IEEE P802.3cg 10BASE-T1S MDI Parallel Inductance

Purpose

- The purpose of this presentation is to:
 - Discuss a proposed resolution to Draft 2.0 comment #364:
 - “Where do the values for L come from? Unless we use PoDL they seem way too high. It states nowhere if this is optional or for PoDL only.”
 - Suggest keeping inductance limits to allow for optional “engineered” power
 - Examine the effect of inductive loading presented by a node on the 10BASE-T1S mixing segment
 - Propose revisions to 147.9.2 and Table 147-3

Origin of inductance limits in Draft 2.0

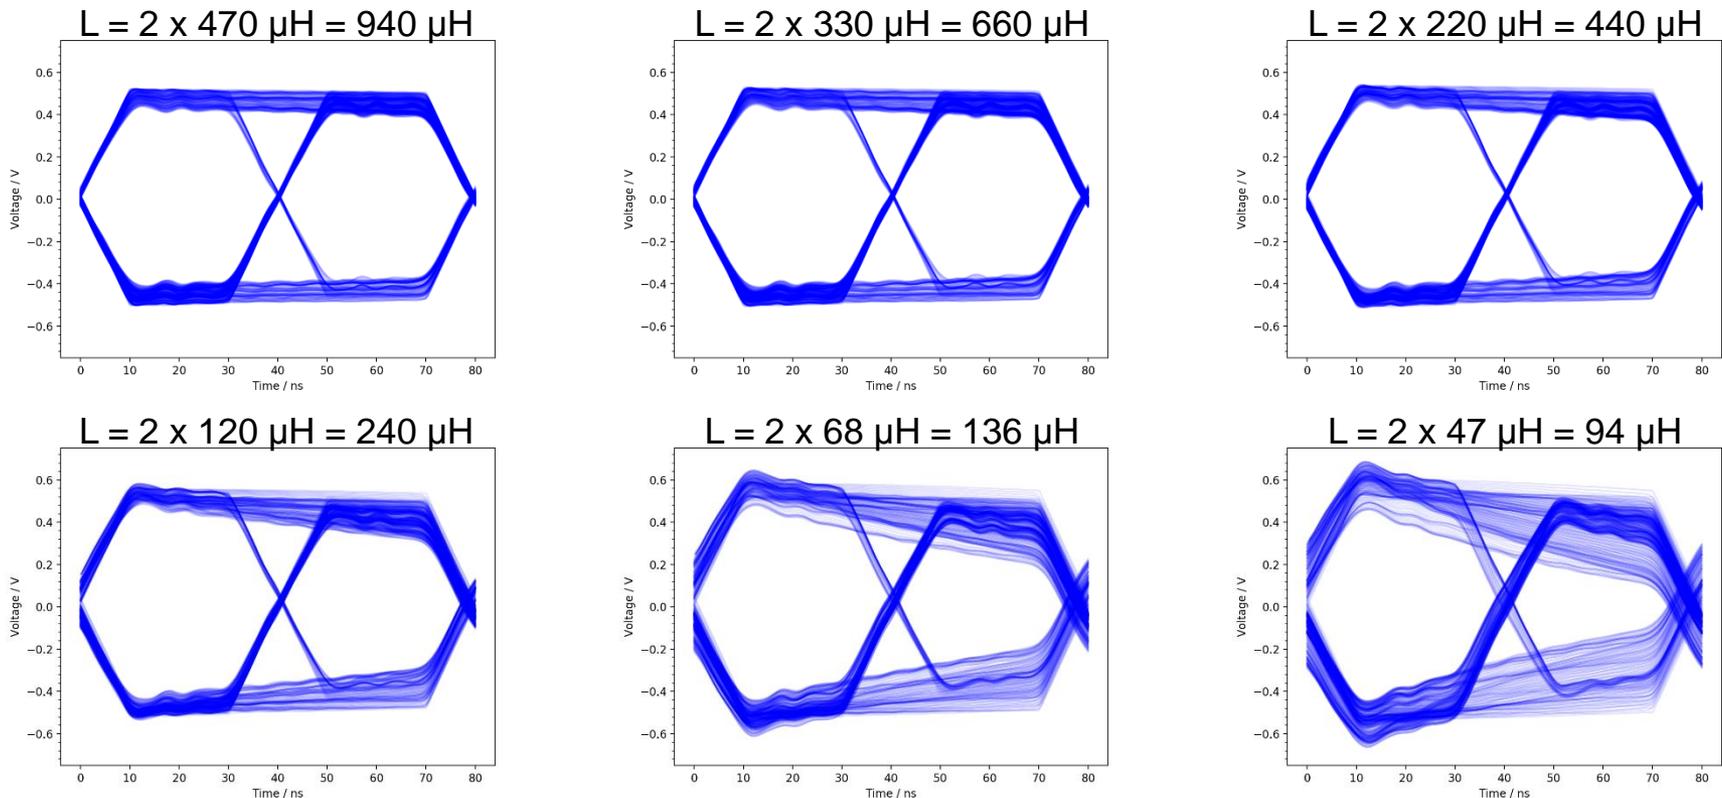
- Limits in Draft 2.0 were derived for a 40 node system
- Inductance impairs the signal as shown below
- Lower inductance values are appropriate (cost effective) for lower node count systems

Revise Table 147-3 as follows:

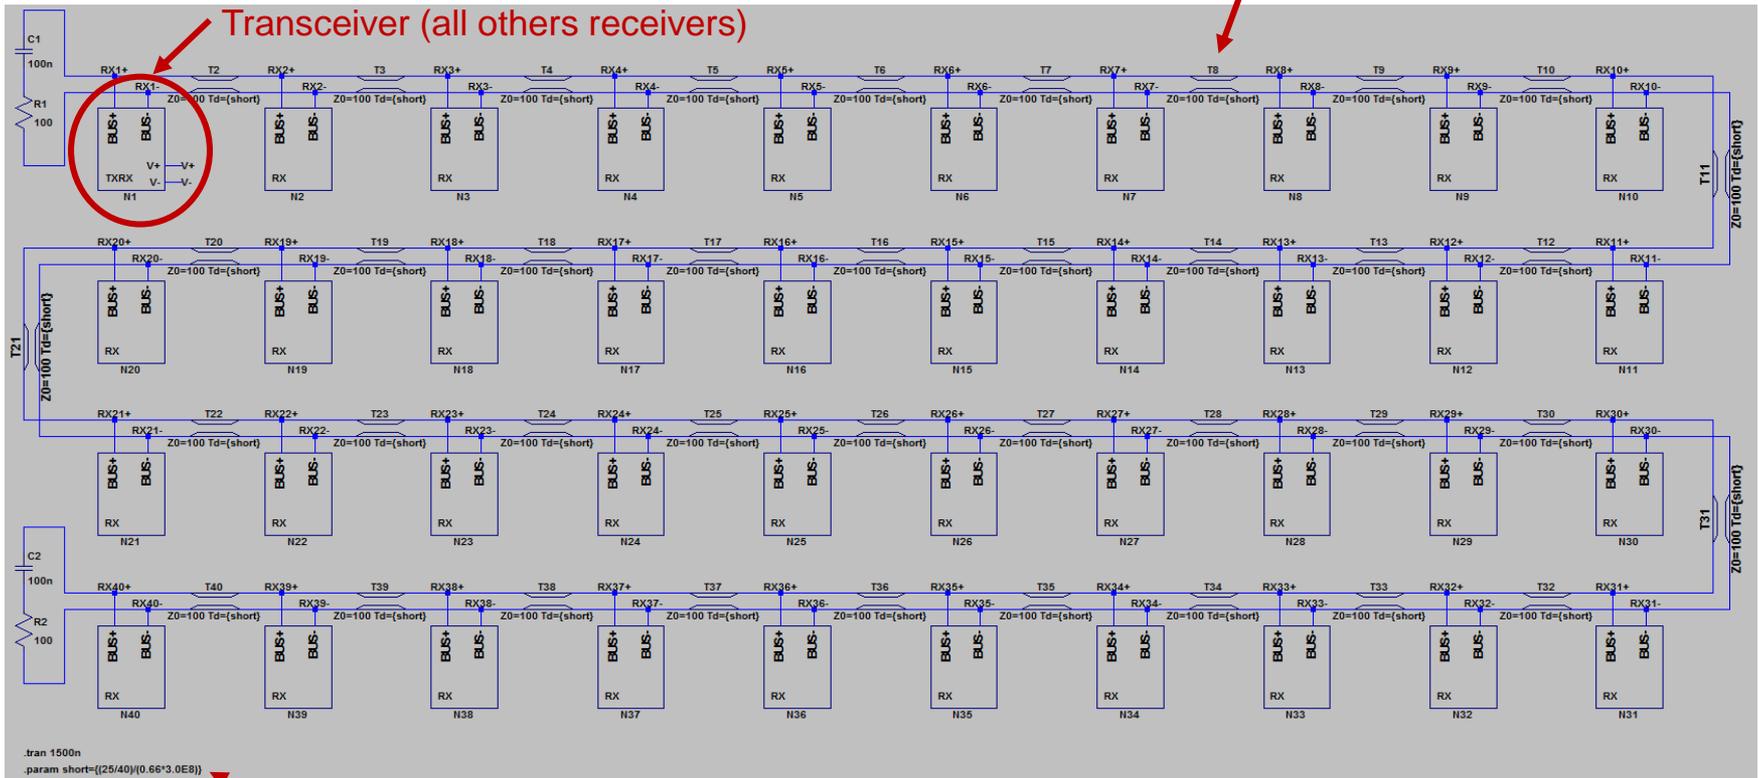
- A minimum inductance per node limit of 80 μH will ensure an 8-node system will work (regardless of locations of nodes on the bus)
- Inductors are only necessary when using DC power on the data lines (“engineered” power)
 - Not including inductors is equivalent to using an infinite parallel inductance
- Keeping a minimum inductance limit prevents accidentally breaking the system, adds minimal complexity to the draft
 - System **will not work** with small ($< 40 \mu\text{H}$) node inductances
- Systems with larger node counts will require engineering with more node inductance
- Maximum inductance is set in practice by parasitic capacitance
- Suggest edits (next slide) to Draft 2.0 to clarify the origin of the inductors and to set new inductance limits

Set the minimum inductance = 80 uH.

Delete the maximum inductance.
